PLATEAU MINING COMPANY

May 14, 1984

RE: NOV 84-4-7-6 and Ditch No. 14

SEDIMENT POND
NO 6 EMBANKMENT
AREA BUILT UP TO ALLOW
ACCESS TO CLEAN POND
WIDENED
DITCH NO 14
WIDENED
WIDENED
UTAH
RECEIVED
MAY 17 1984
DIVISION OF OIL
GAS & MINING

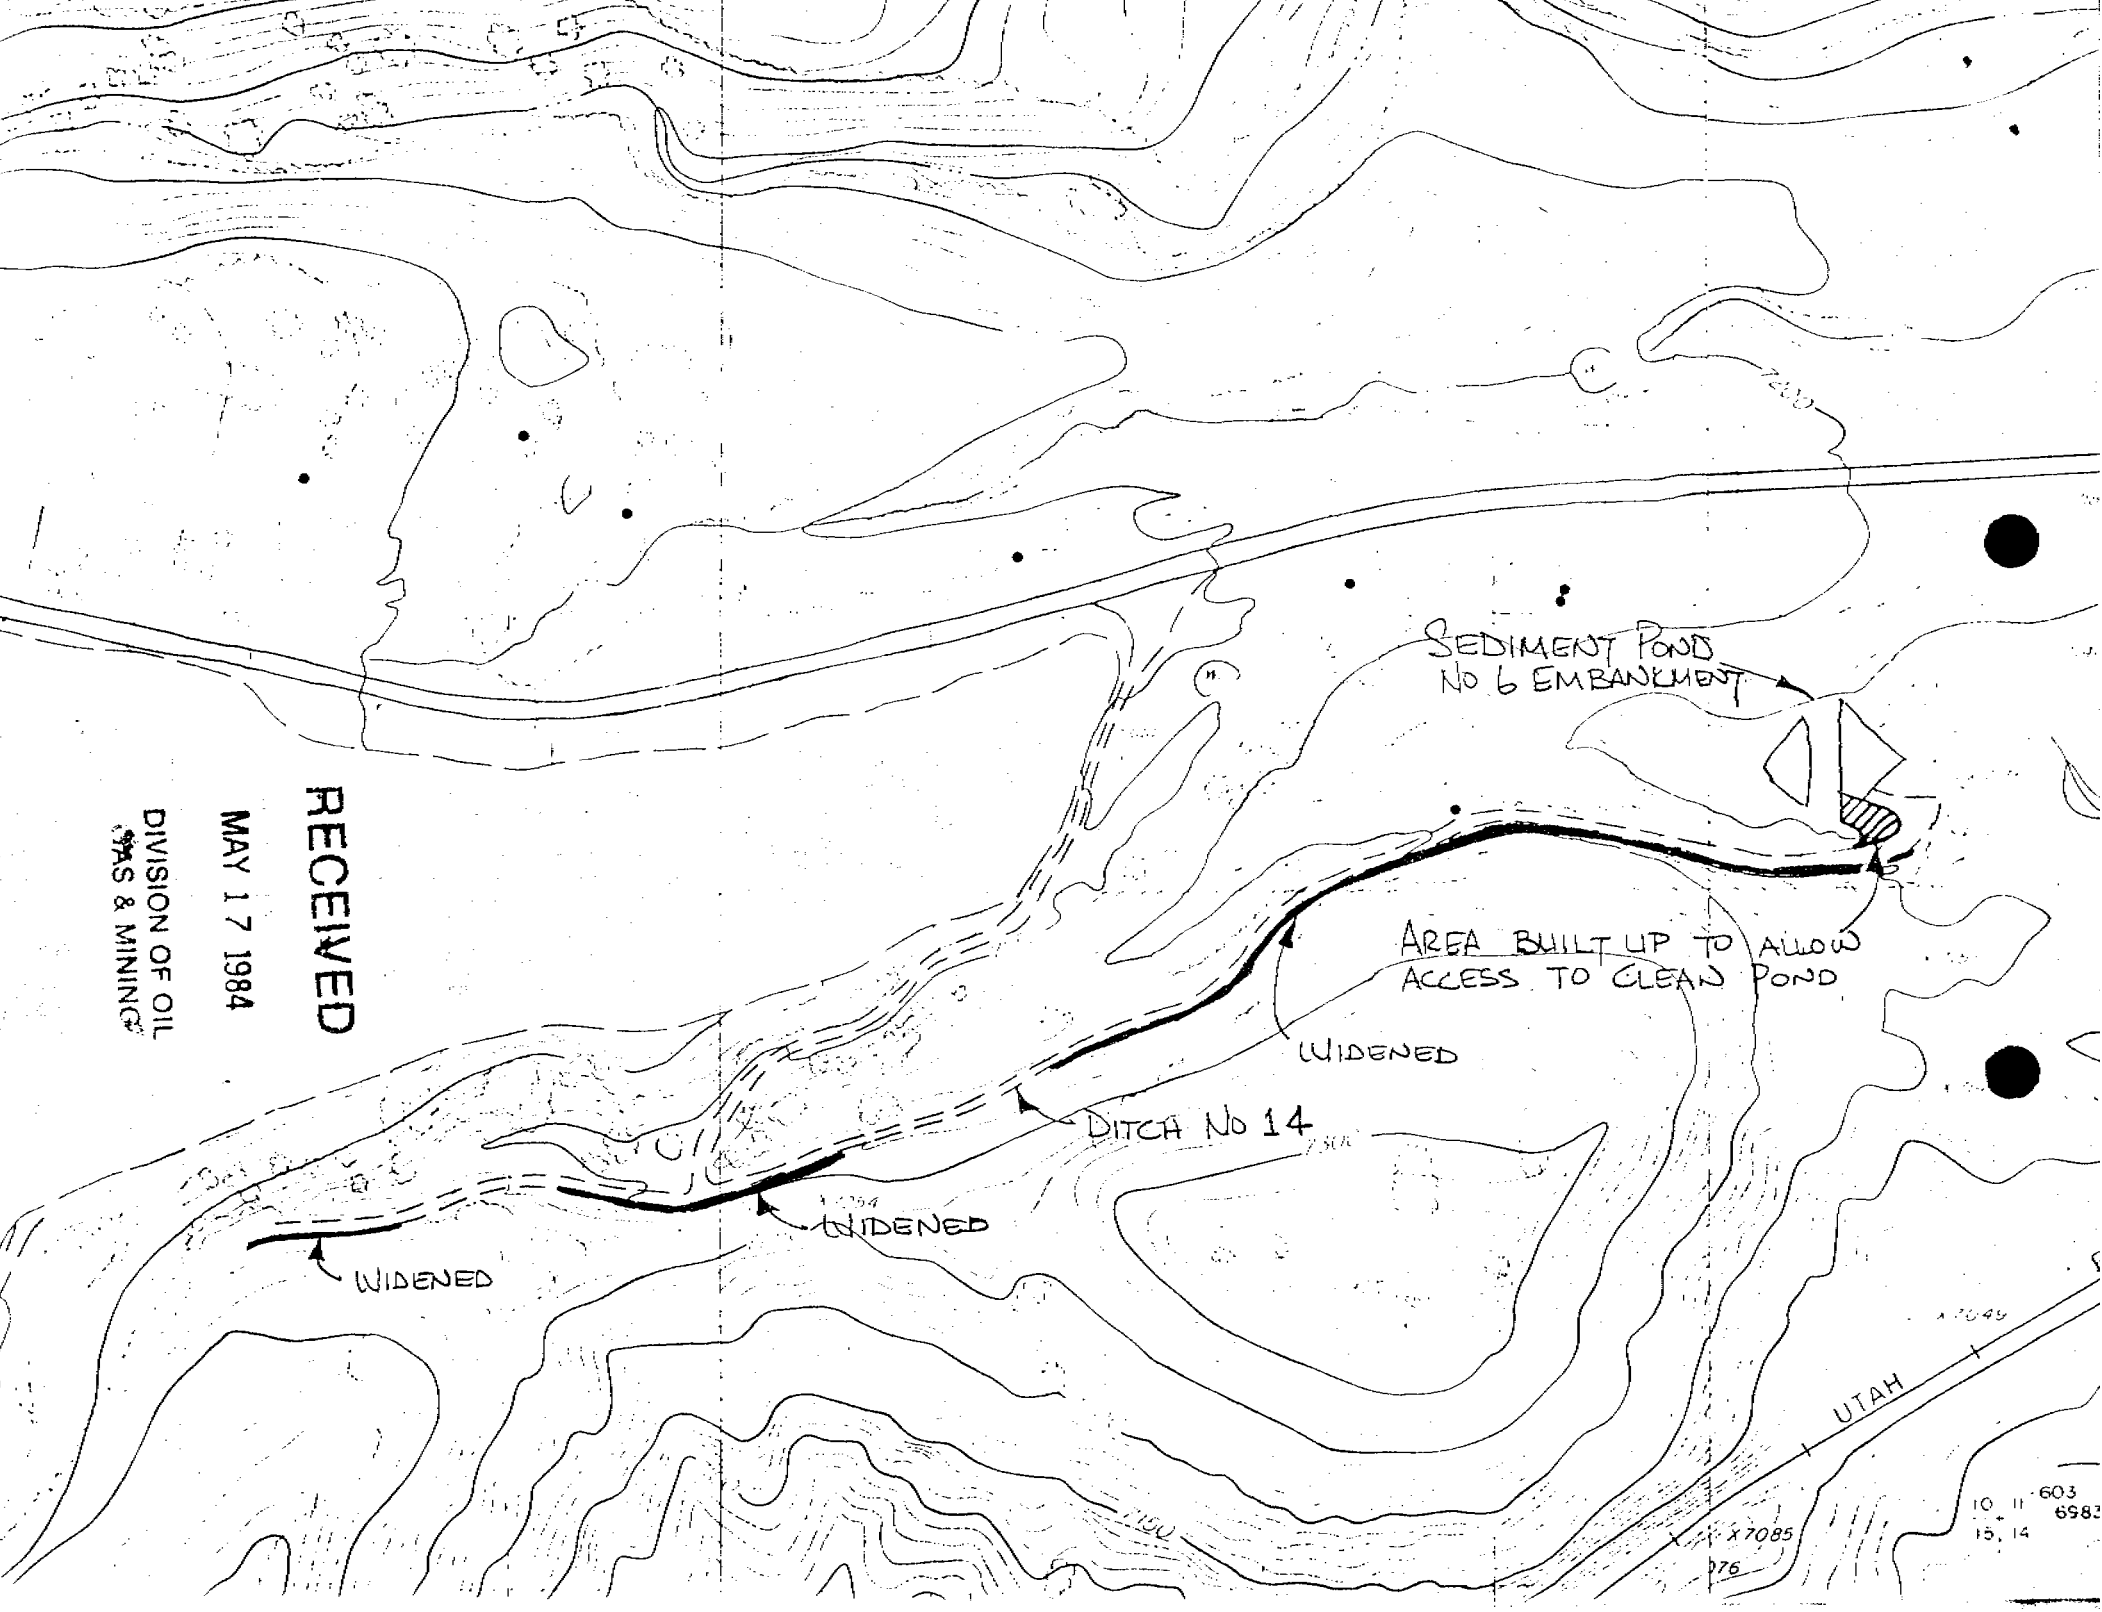
-Ditch No. 14 - Refer to the attached map-
To allow room for an access road parallel to Ditch No. 14, we have had to widen the roadway in several areas. There was no feasible way to save the small amount of topsoil on the widened areas. The cut material was sidecast and/or pushed to the bottom of the road adjacent to Sediment Pond No. 16. Upon reclamation, this material will be used to reclaim the road and ditch cut.

To enhance access to Pond No. 6 for cleaning and maintenance, the area at the south end of the embankment was built up. This will allow vehicular access to the top of the embankment.

The approval letter for Ditch No. 14 dated 11/15/83, called for a May 15 completion. We would ask at this time for an extension of two weeks to complete the job.
